# UNITED STATES PATENT AND TRADEMARK OFFICE

APPLICATION NO.	FILING DATE	FIRST NAMED INVENTOR	ATTORNEY DOCKET NO.	CONFIRMATION NO.
10/576,562	03/05/2007	Yoon-Seob Eom	P-0775	4135
34610	7590	10/26/2009	EXAMINER	
KED & ASSOCIATES, LLP P.O. Box 221200 Chantilly, VA 20153-1200				BAUER, CASSEY D
ART UNIT		PAPER NUMBER		
3744				
MAIL DATE		DELIVERY MODE		
10/26/2009		PAPER

<b>Office Action Summary</b>	<b>Application No.</b>	<b>Applicant(s)</b>	
	10/576,562	EOM ET AL.	
	<b>Examiner</b>	<b>Art Unit</b>	
	Cassey Bauer	3744

**DETAILED ACTION**

**Reference 1**

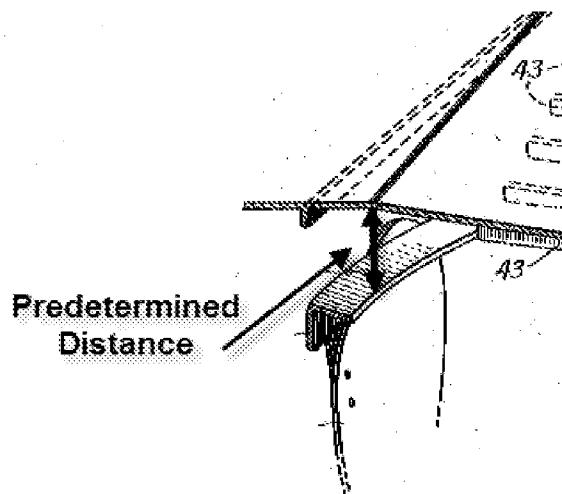
an outdoor heat exchanger (15) mounted inside the case (3) positioned on the outdoor side (6) that heat-exchanges with outdoor air; an axial fan (17) provided opposite to the outdoor heat exchanger (15) that blows the outdoor air by a centrifugal force; a condensate dispersing device (35) that disperses condensate collected at a lower portion of the case (3) to a surface of the outdoor heat exchanger (15), see figure 2 and column 1 lines 20-26; and a shroud (20) in which the outdoor heat exchanger (15) is mounted, see figure 1, wherein the shroud (20) includes a condensate guide (43, 45) the condensate guide comprising an inclined portion (41) of an upper wall (24) of the shroud (20) that inclines from a point a predetermined distance from the axial fan, see Reference 1 below, downward toward the outdoor heat exchanger (15) see at least figure 5, the inclined portion (41) guiding the condensate dispersed to the at least one inner surface of the shroud (20) by the condensate dispersing device (35) to the outdoor heat exchanger (15).

As evidenced by at least figure 5 of the disclosure of Kimroff, the condensate guides (43) comprises an upper portion (41) of an upper wall (24) of a shroud (20) that inclines from a predetermined distance, see Reference 1 above, from the axial fan (17) toward the outdoor heat exchanger (15). Therefore, the apparatus as disclosed by Komroff meets the limitations of claims 13-17 and the rejections above are proper and remain.
